PROJECT BORN FRAGRANCE - shop fit-out

SHEET **SD-02**

TITLE **DISPLAY / FURNITURE PLAN**

REV 00 - preliminary

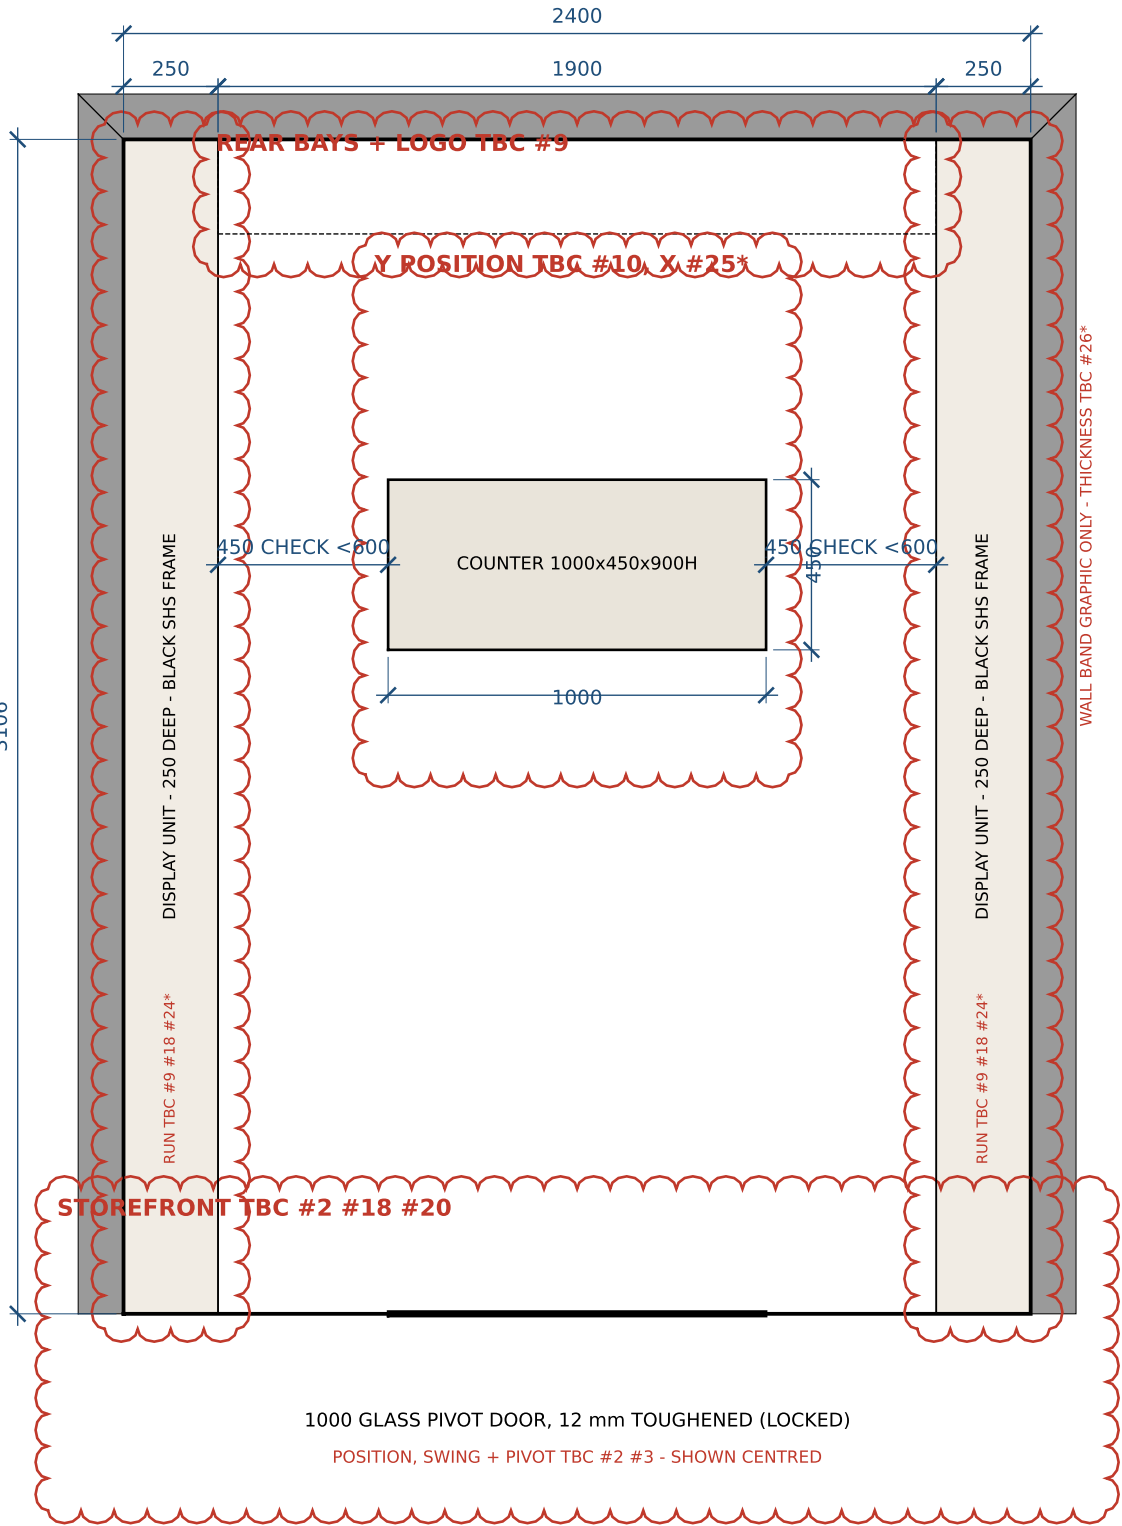
Counter centred x 700-1700 is a PROPOSAL.
Side clearance 450 < 600: CHECK staff access.
Exclusions: no timber, brass, plants, products.

BAYS ~600, COUNT TBC #24*
BASE CAB TBC #7

FLOOR LED TBC #13

- #7 Base cabinet height and door type
- #9 Rear wall bay width, shelf count, logo size and height
- #10 Counter distance from rear wall and staff clearance
- #13 Floor-level LED strip (visible in render): keep or omit
- #18 Storefront display column depth, and shelf facing (street, shop or both)
- #24* Side bay count, widths and upright spacing
- #25* Counter lateral position (centring is a proposal)
- #4 Is 2400 x 3106 the finished size (after plaster)?
